B U L L E T I N 6

PROJECT: St. Denis Community School

RE: W12x19 Steel beam moves 3rd & 4th FLS at Bay Windows only

MODIFIED
THIRD FLOOR FRAMING PLAN

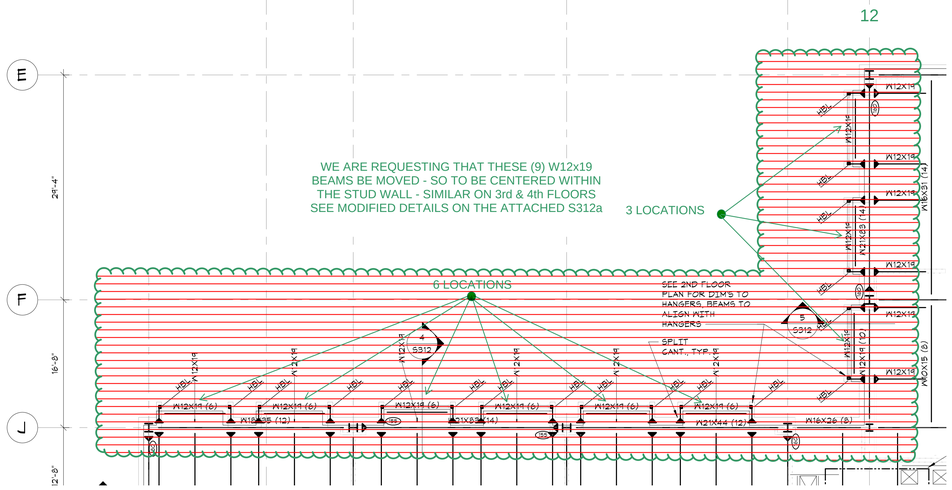
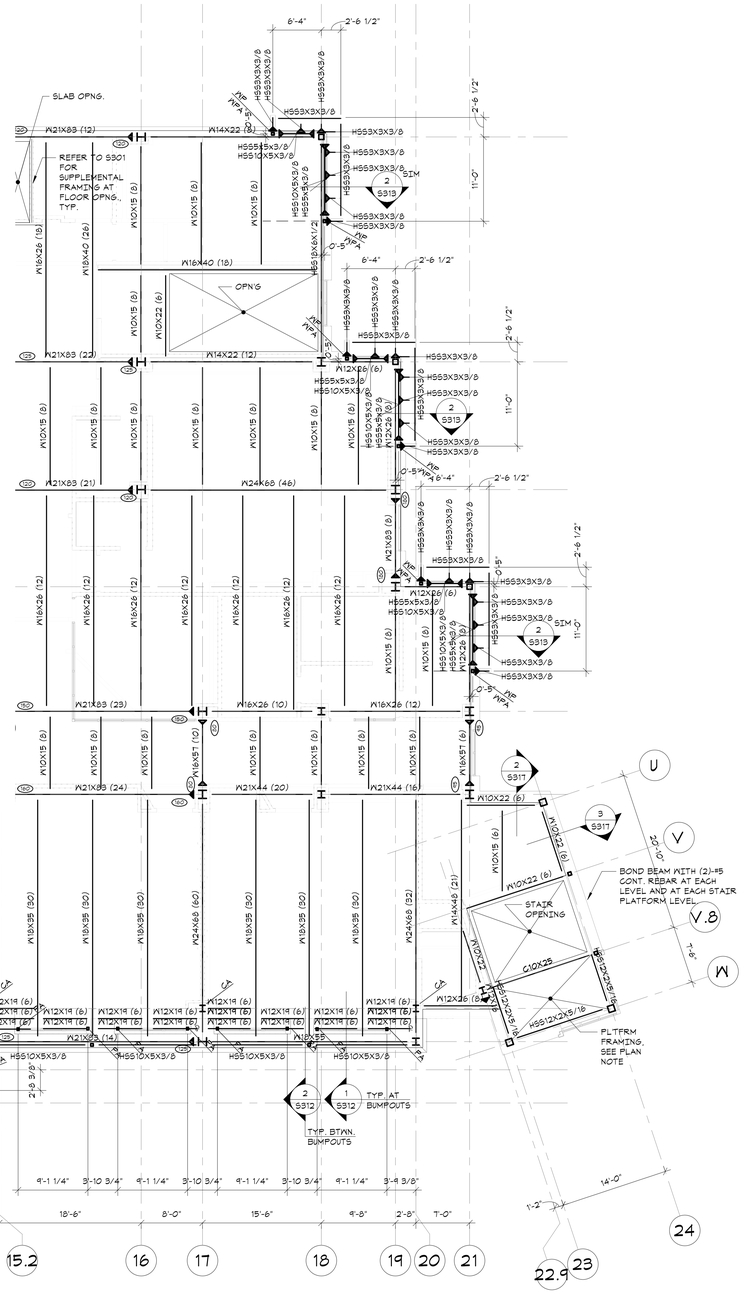
See the attached 3 drawing (S103, S104, S312a) excerpt describing a spandrel beam relocation for the bay windows along the North & West facades on the 3rd & 4th floors.

REQUESTED
08/02/22

MODIFIED
FOURTH FLOOR FRAMING PLAN

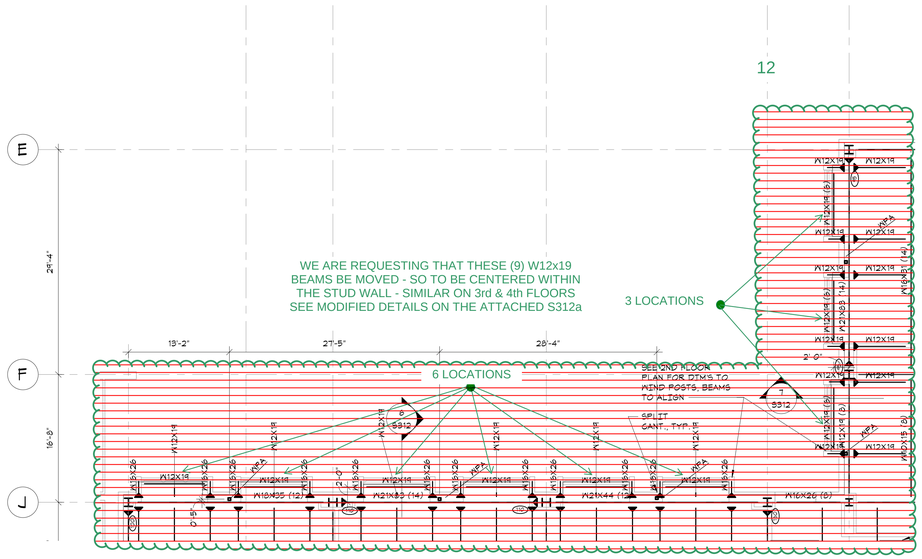
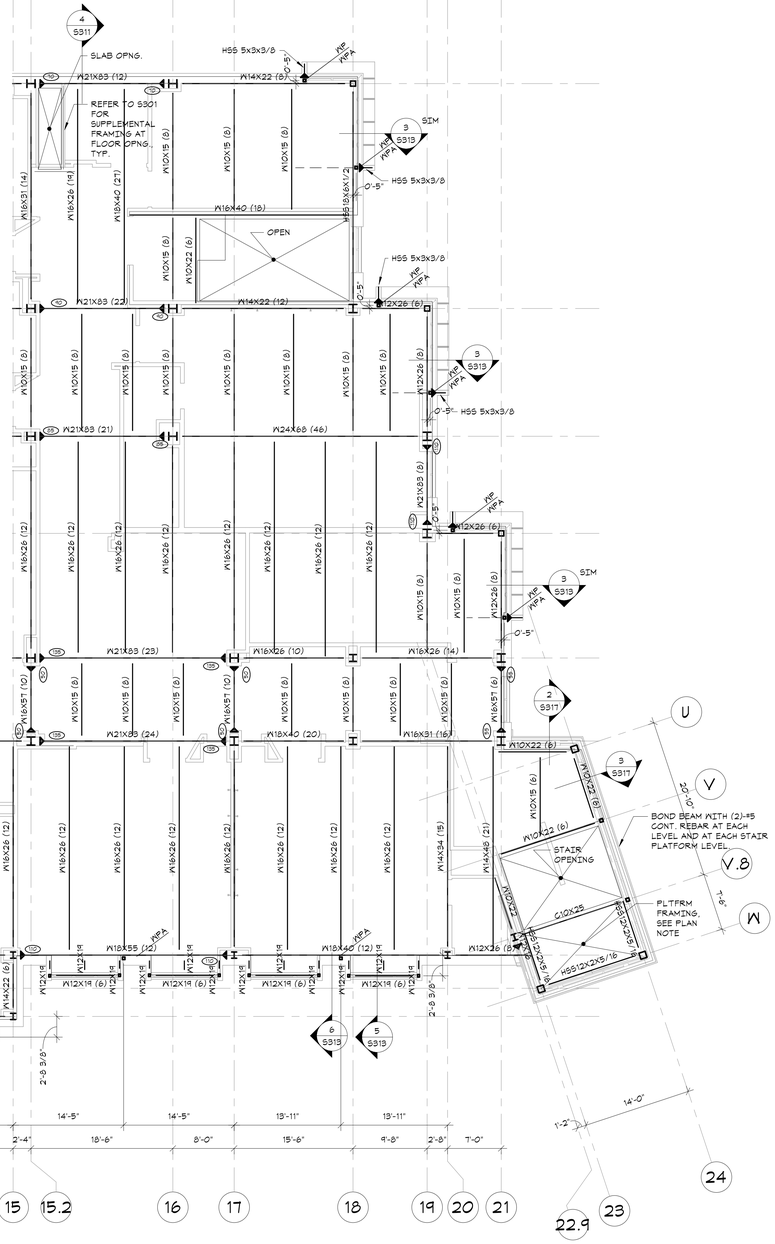
REQUESTED
08/02/22

4 SECTION
3/4" = 1'-0"

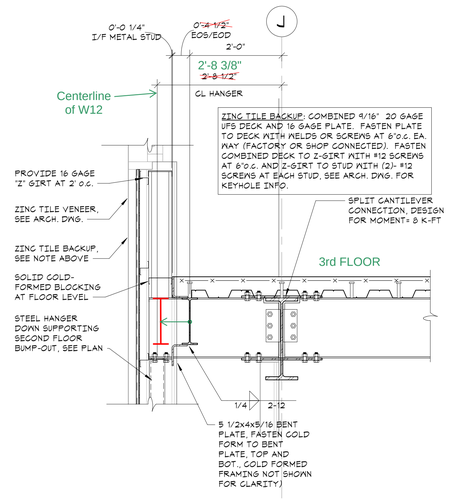
PLEASE ADJUST THE LOCATION OF THE W12X19 TO BE CENTERED WITHIN THE EXTERIOR BACKUP STUD WALL -- AS DEPICTED IN THE ARCHITECTURAL WALL SECTIONS & ENLARGED DETAIL D/A806 ON THE 3rd & 4th FLOORS ALONG THE J & 12 COLUMN LINES

NOTE: THE EOS HAS ALREADY BEEN MOVED TO BE 2'-11 3/8" FROM THE COLUMN LINES J & 12
